City of Ryde Local Planning Panel Meeting No. 3/19

- 2 330 ROWE STREET, EASTWOOD - DEMOLITION OF EXISTING DOUBLE GARAGE, ALTERATIONS AND ADDITIONS TO AN EXISTING DWELLING FOR USE AS A CHILDCARE CENTRE FOR 66 CHILDREN WITH BASEMENT CARPARKING FOR 6 VEHICLES AND 3 AT GRADE CAR PARKING SPACES - LDA2019/0018**

City of Ryde Local Planning Panel Report

Figure 12: Overall height of basement wall and acoustic fence above, as viewed from Rowe Street.

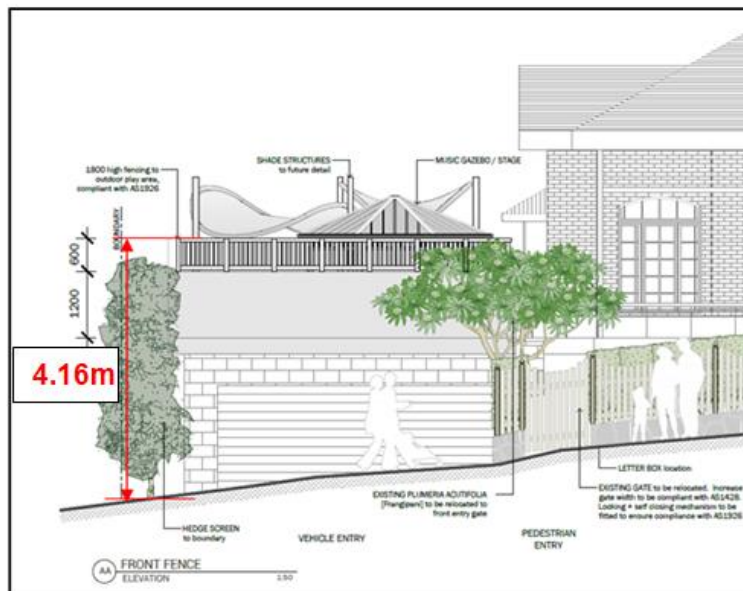
In order to minimise noise levels, a 1.8m high acoustic fence will be erected along the top of the basement on the eastern and southern sides. Consequently, the overall height of the basement wall and acoustic fence will be between 3.44m and 4.16m high along the eastern boundary, which is illustrated in **Figure 12**. Considering this structure will be offset from the boundary by only 900mm, it results in excessive bulk, a poor built form, and will be obtrusive on the occupants of the adjoining dwelling at 328 Rowe Street. This is not a desired outcome, is out of character for the area and found to be unacceptable.

Noted. As state above, the overall height of the basement wall and acoustic fence above will be between 3.44m and 4.16m high, which is illustrated in **Figure 12**.

Figure 13: Overall height of basement wall and acoustic fence above, as viewed from the rear.

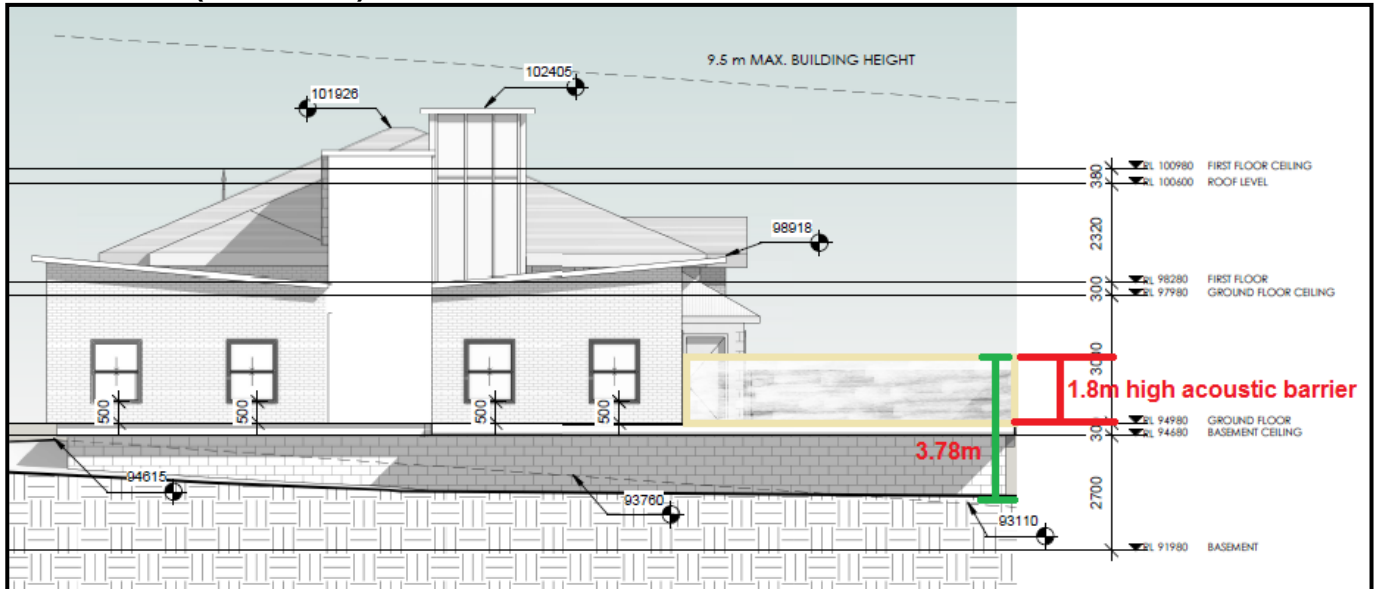
Similarly, the overall height of the basement wall and acoustic fence will be between 2.98m and 3.78m high along the southern boundary, which is illustrated in **Figure 13**. Considering this structure will have a zero setback, it results in additional shadowing on the occupants of the adjoining dwelling to the rear at 32 Darvall Road. Once again, this is not a desired outcome and found to be unacceptable.

Figure 14: Landscape plan show areas of concern

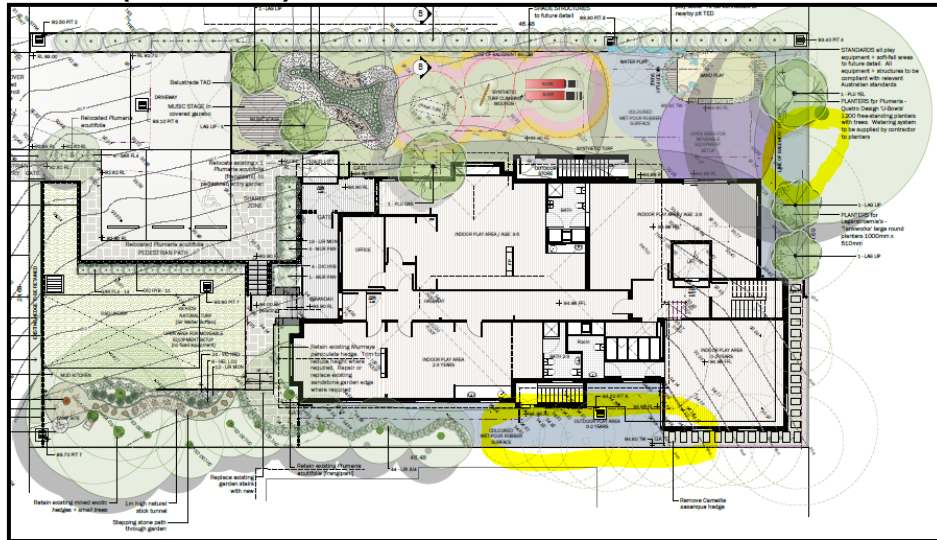
The proposed landscape design does not satisfy the requirements of the Child Care Planning Guideline in that a garden bed with a minimum width of 1 metre has not been provided to the full perimeter of the proposed child care centre which is required to minimise overlooking. In this regard, there is a gap in the garden beds on the southern boundary and eastern boundary adjacent to an adjoining dwelling (No. 332 Rowe Street) as shown in **Figure 14**.

Figure 15: Location of outdoor play areas in relation to the child care centre

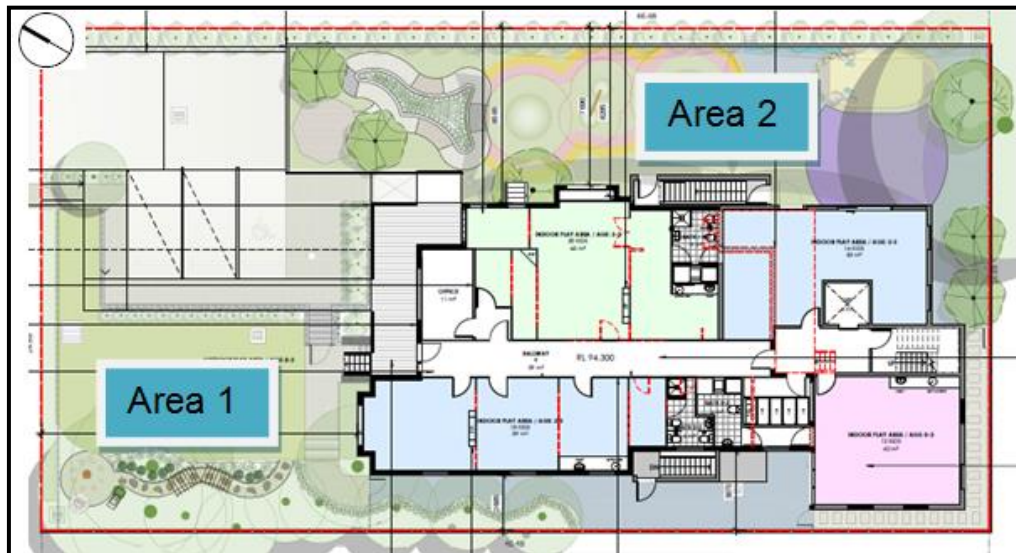
There are two (2) outdoor play areas as illustrated in **Figure 15**. Area 1 is located within the front setback area and will receive direct sunlight all day on 21 June. However, Area 2 is located along the eastern side of the existing building which will be overshadowed in the morning (due to the neighbouring 2 storey dwelling) and between 1pm and 3pm. The applicant has not submitted hourly shadow diagrams which demonstrate the exact extent of overshadowing to this particular play area.

Figure 1

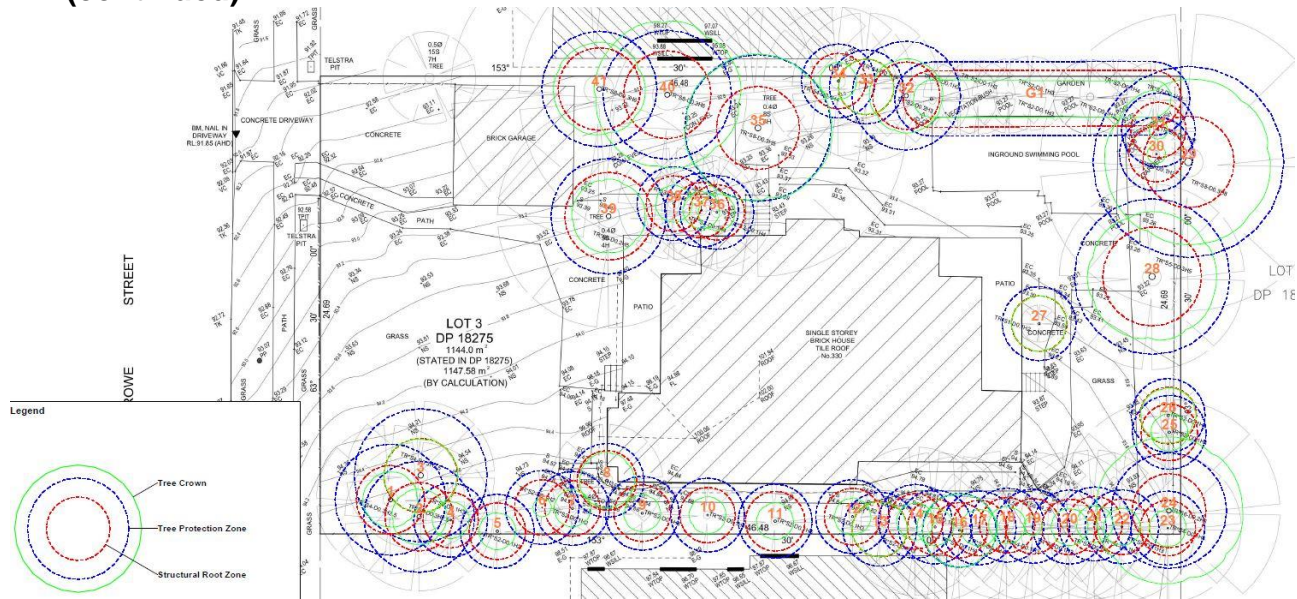
Tree 29. The Arborist Report recommends root investigations of this tree as it has a total Tree Protection Zone encroachment of 40%. This investigation is required with the Development Application to access if the tree can be retained.

Figure 1: Landscape Plan extract indicating insufficient planting bed width adjacent the driveway and failure to provide any planting between the driveway and dwelling façade.

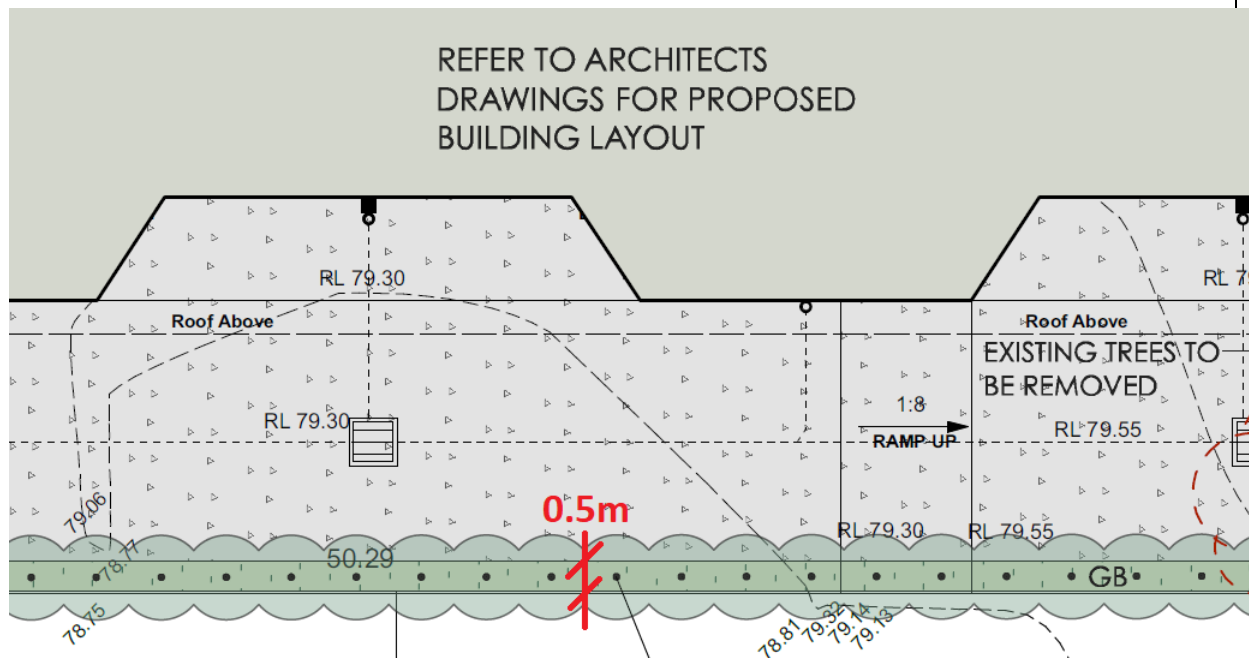
Insufficient Planting Bed Width Adjacent Driveway: A review of the plans and documentation submitted has revealed that the planting strip indicated between the driveway and the adjoining property boundary is only 0.5 metres wide and does not meet the minimum control of 1.2 metres as outlined under Part 3.4 *Multi dwelling housing* of Ryde DCP 2014. In addition, as demonstrated in **Figure 1** below a planting strip at least 1 metre wide has not been provided between the driveway and the wall of the dwellings (also not meeting the control under Part 3.4 of Ryde DCP 2014). As a result of the non-compliances in this case, the current design is not considered to provide a suitable level of privacy screening both to and from the proposed driveway.

Figure 1: Landscape Plan extract indicating insufficient planting bed width within private open spaces to allow suitable screen planting to be provided

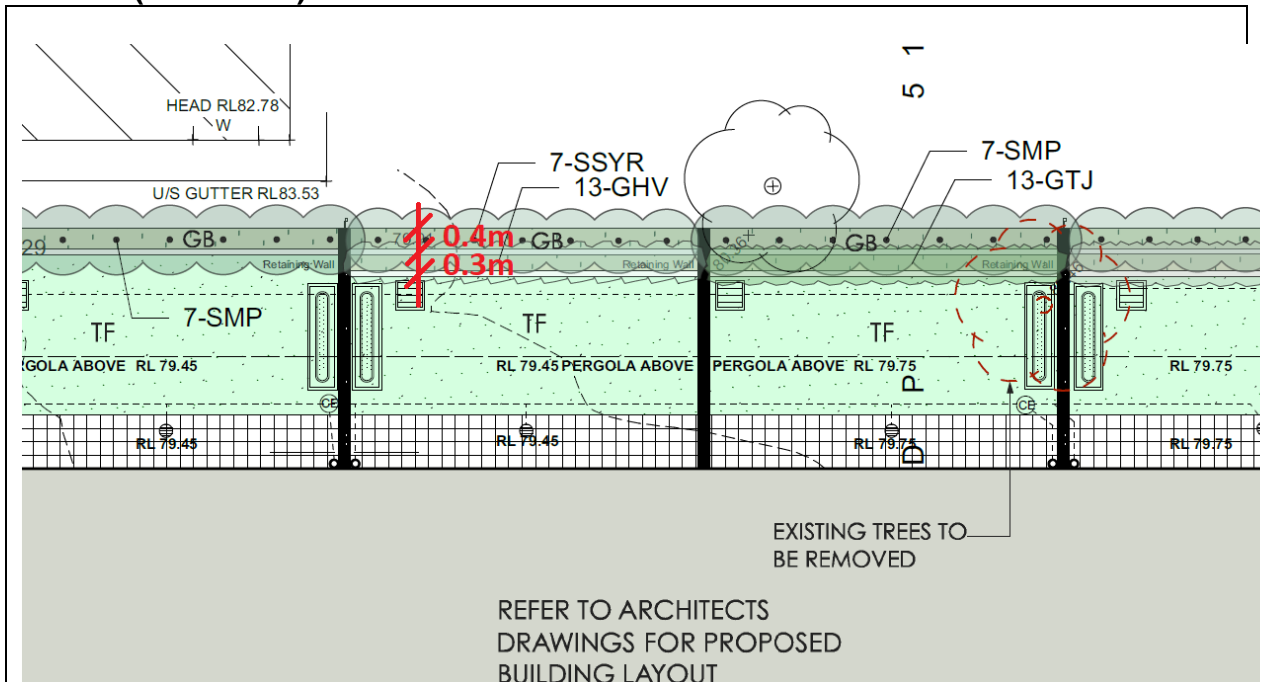
Insufficient Planting Bed Width Adjacent POS Boundaries: The inclusion of stepped retaining walls along the rear boundary reduces the available width of each planting bed to 0.3-0.4 metres. This does not meet the minimum control of 1.2 metres as outlined under Part 3.4 *Multi dwelling housing* of Ryde DCP 2014 and as such is not considered a suitable outcome as insufficient soil volumes are available for establishment of suitable screen planting.
